NORTHWEST HILLS REGIONAL ANIMAL FACILITY

S/P+A PROJECT NO. 17.105

DATE: May 7, 2021

The following changes to the Drawings and Project Specifications shall become a part of the Drawings and Project Specifications; superseding previously issued Drawings and Project Specifications to the extent modified by Addendum No. 2.

Drawing Number:
A111

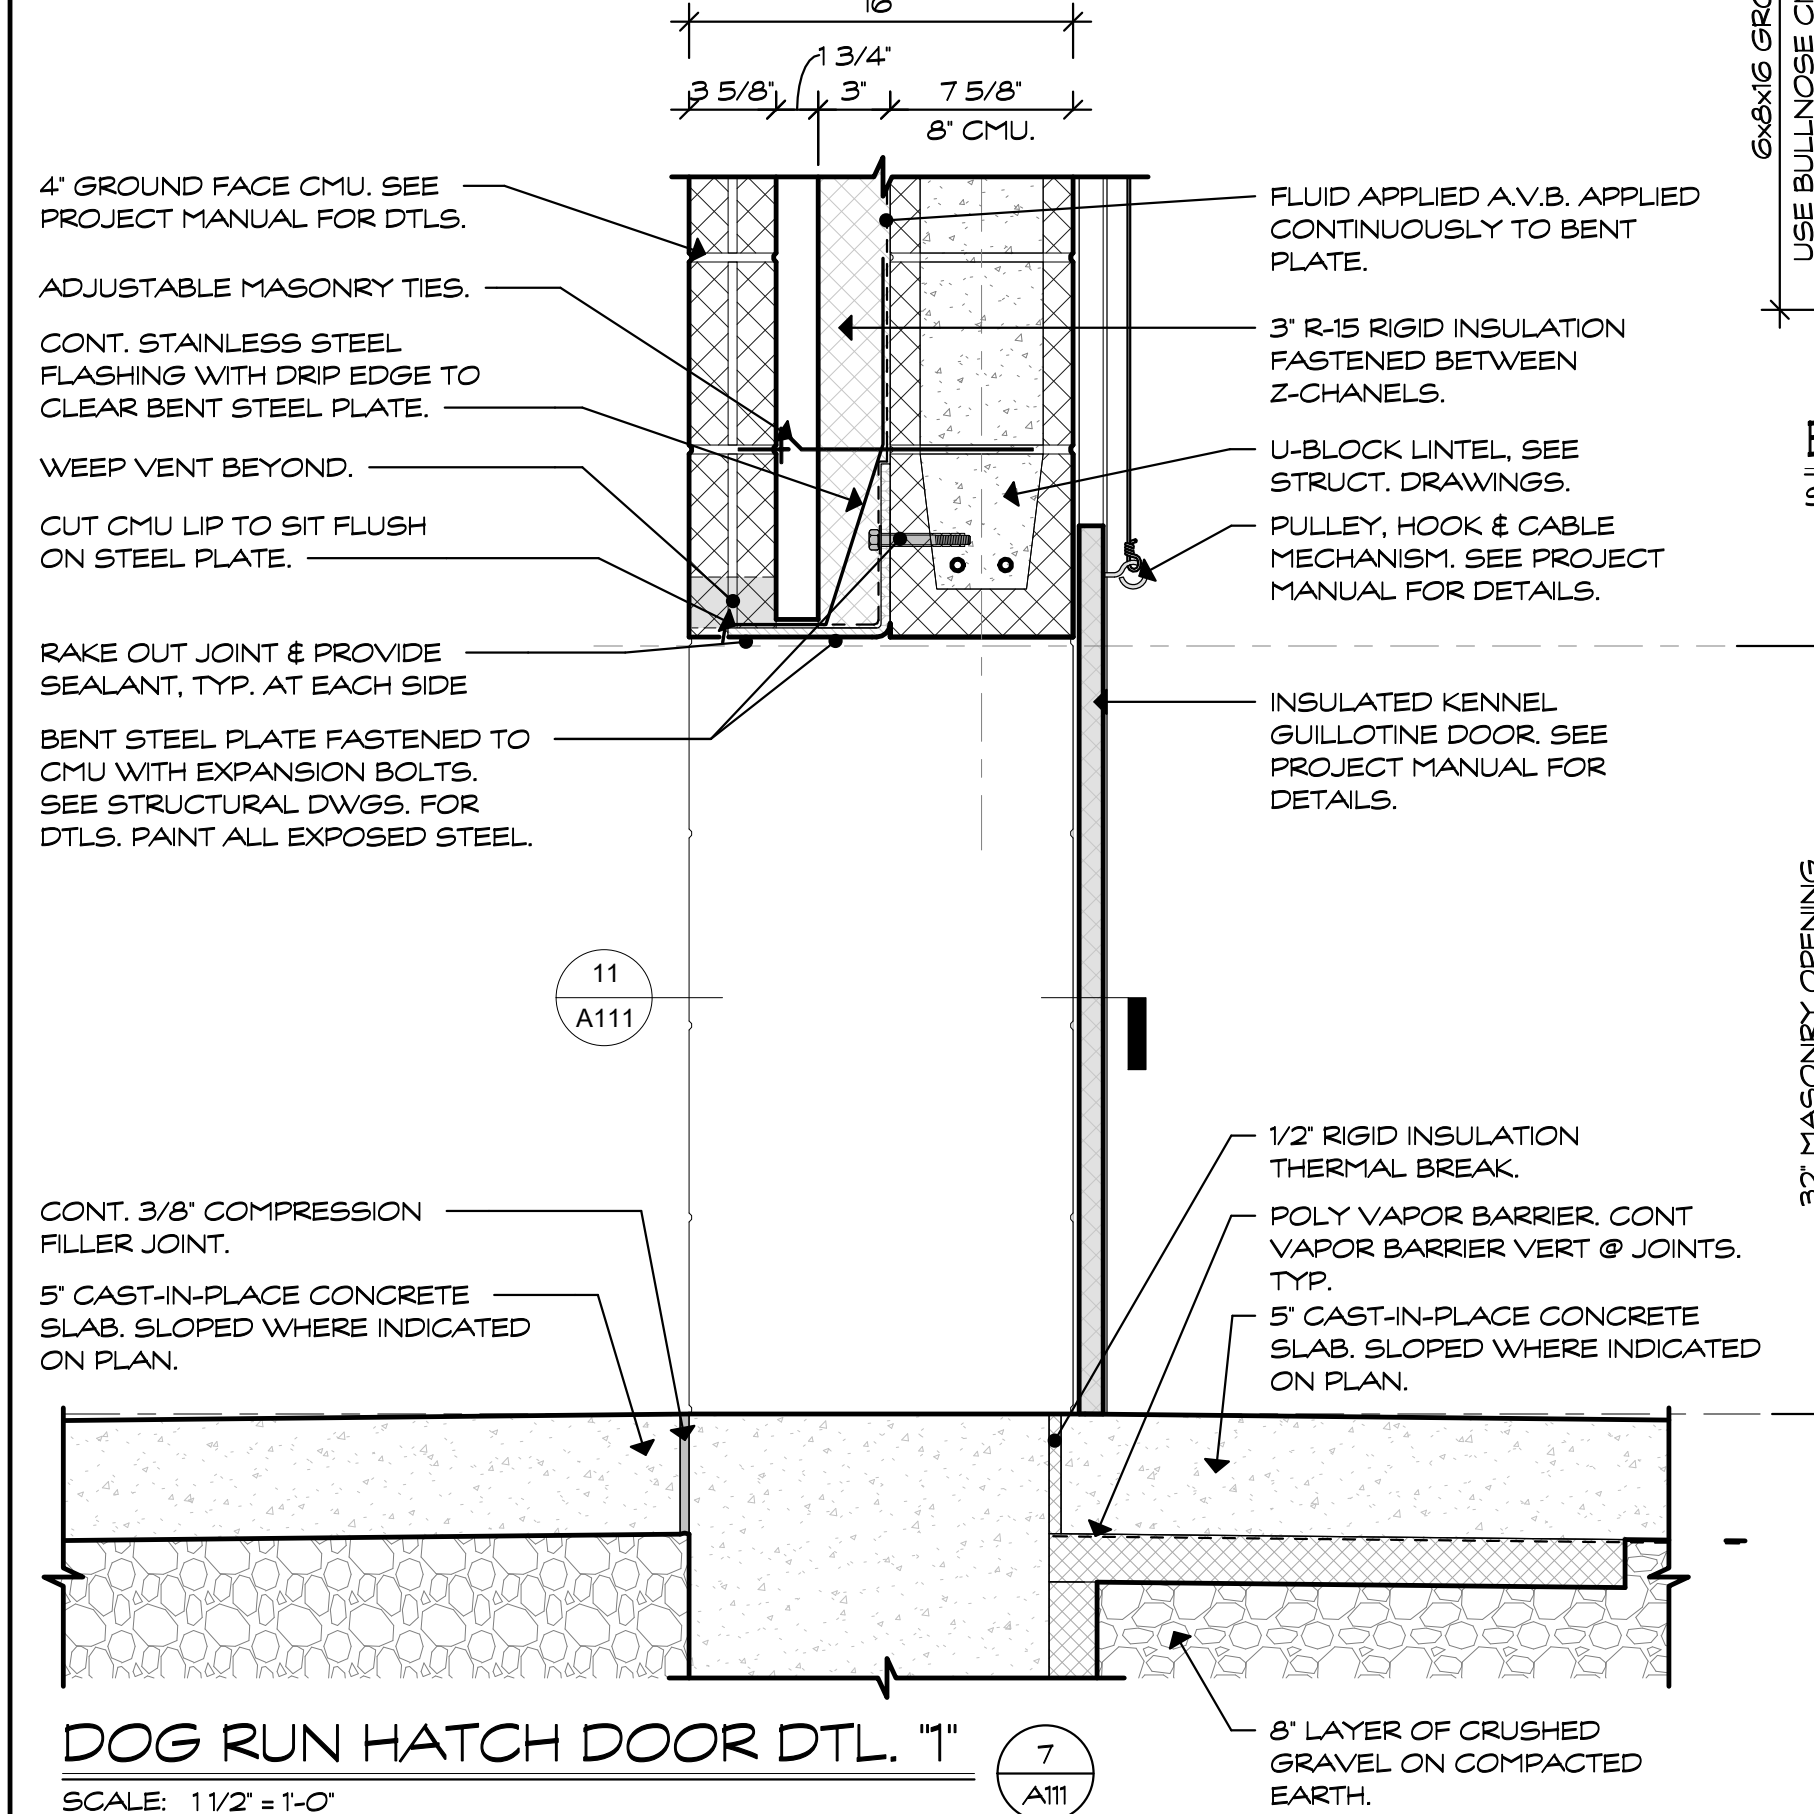
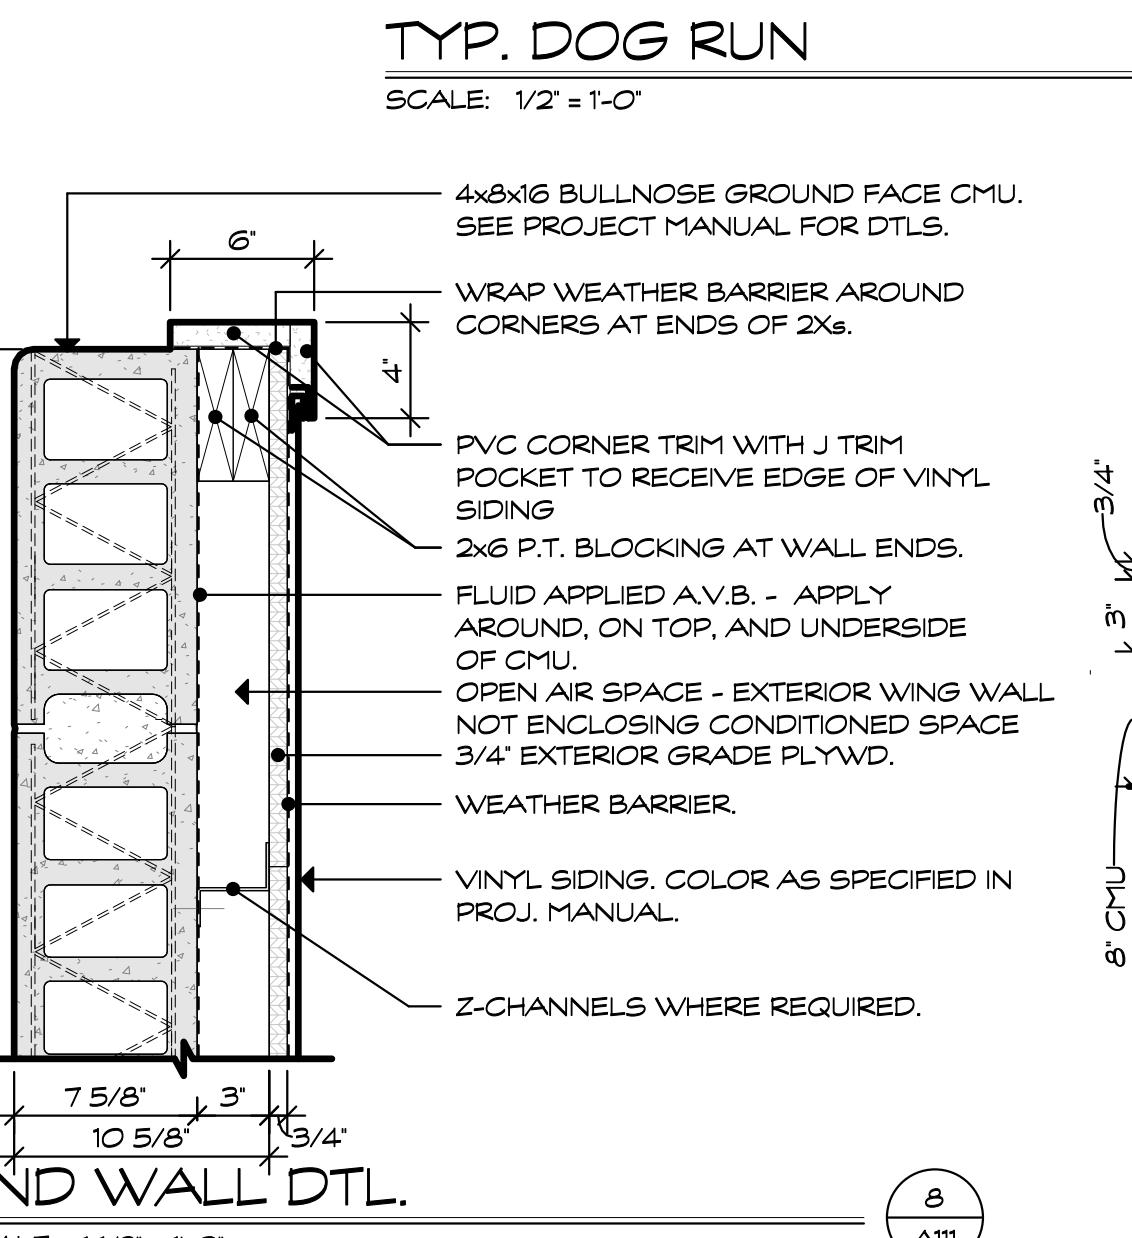
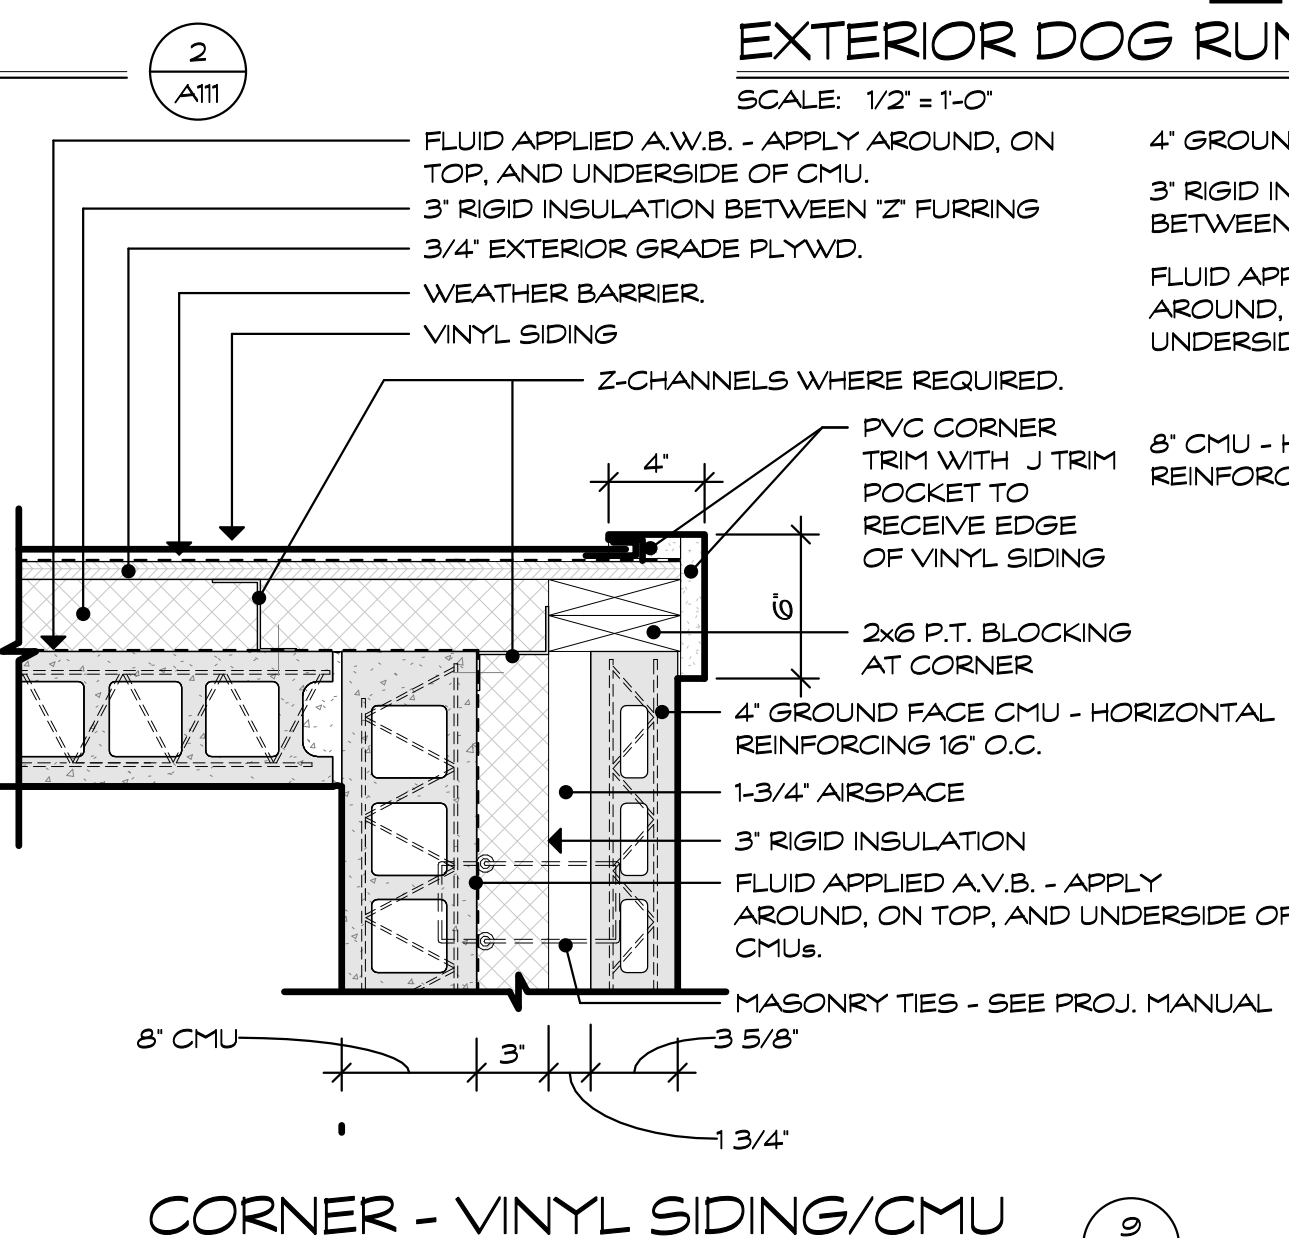
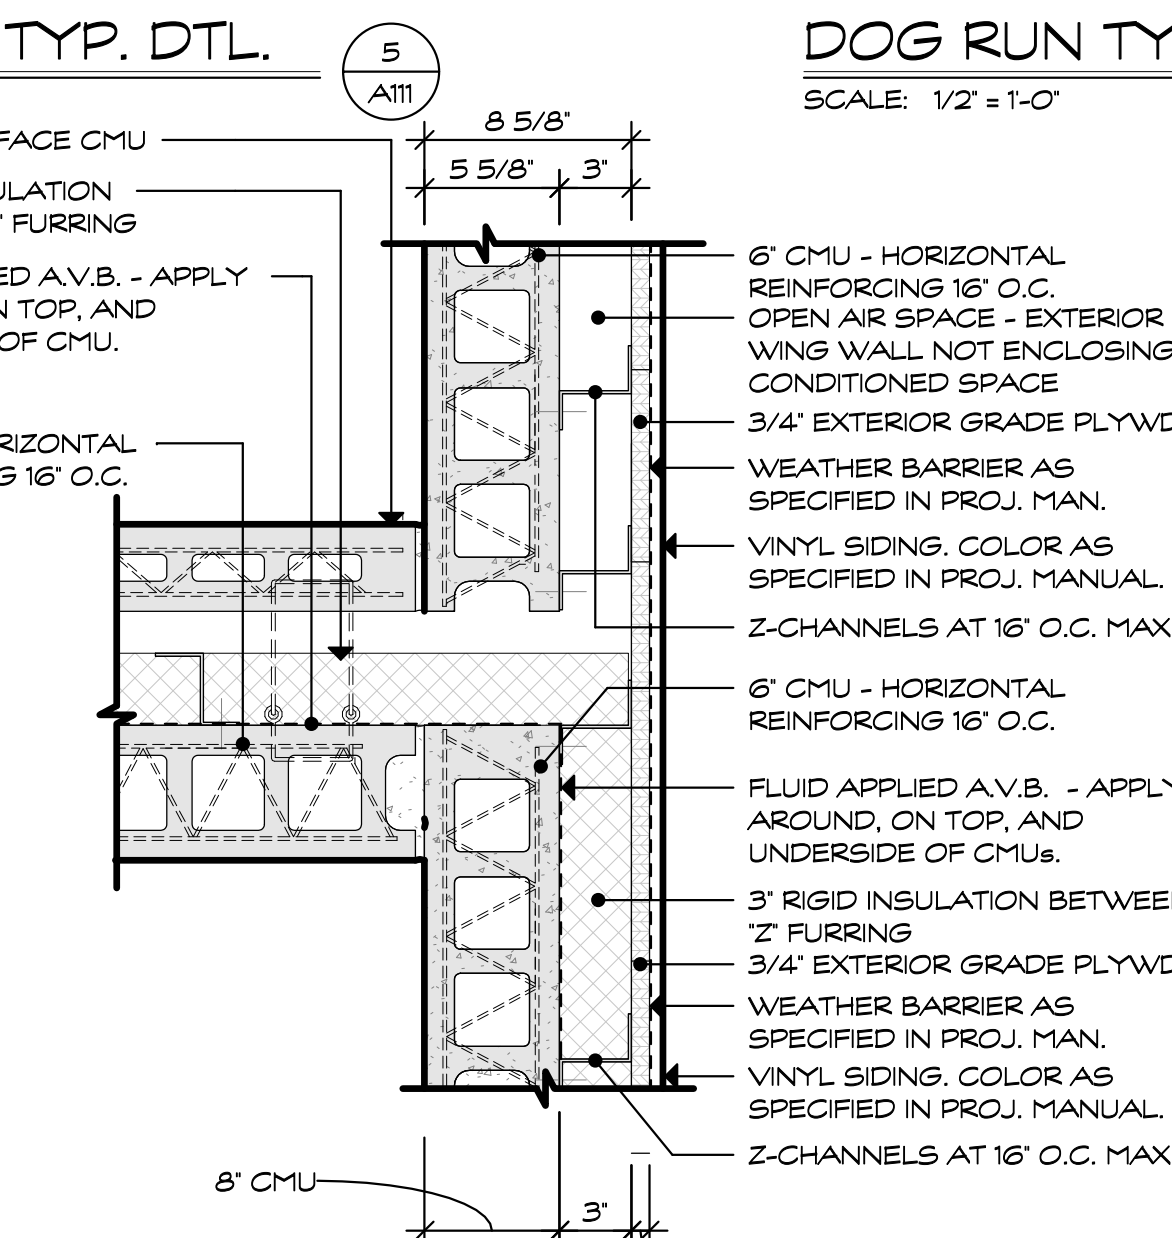
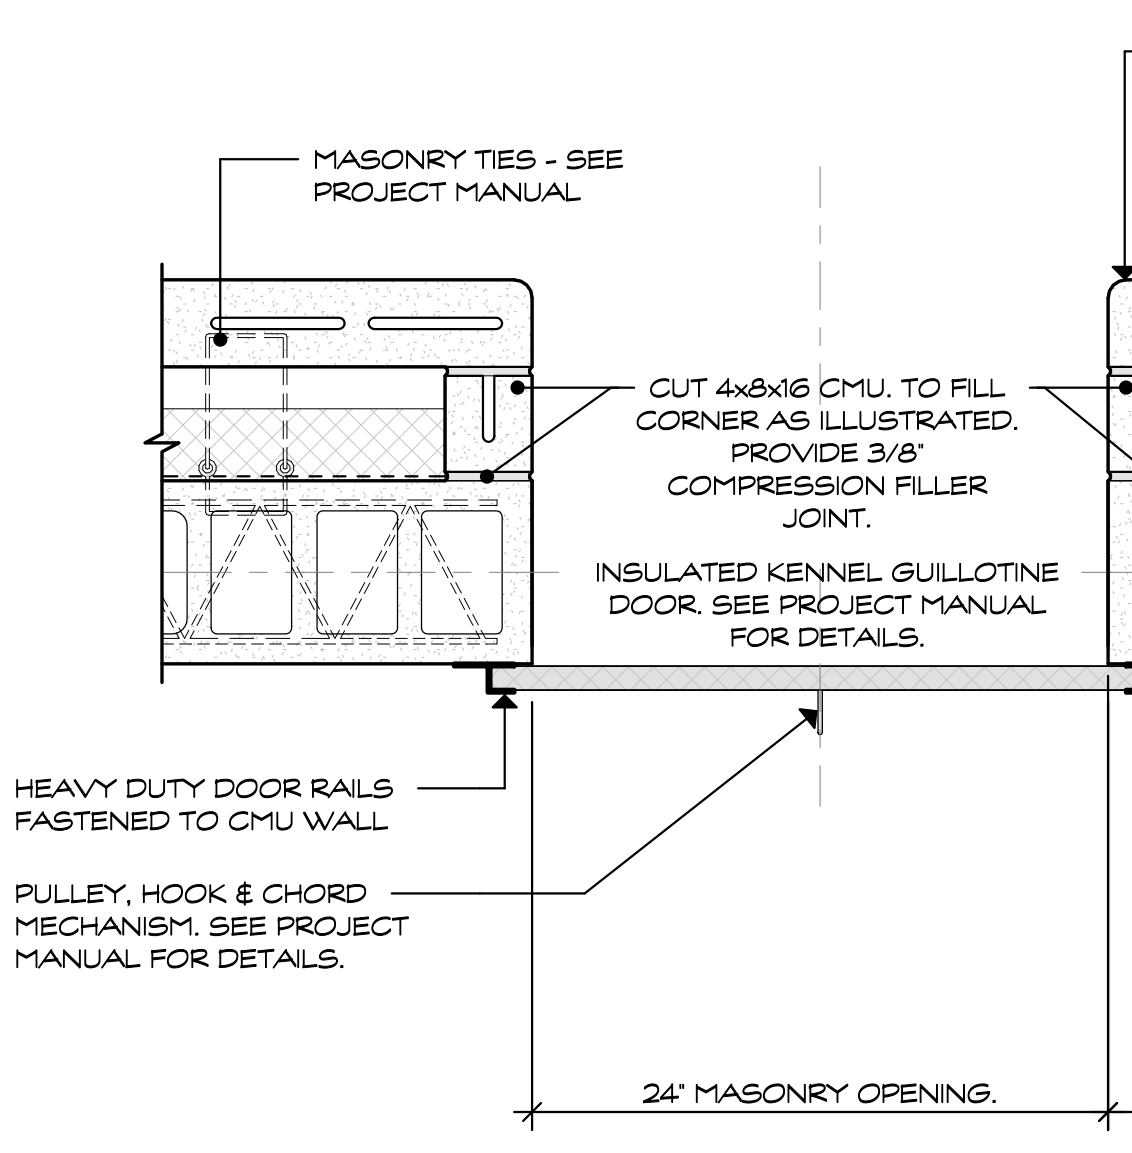
Revision:	Description:	Date:	Revised By:
BID SUBMISSION		04/16/2021	
1	DOG-RUN/FENCE UPDATE	05/07/21	BV
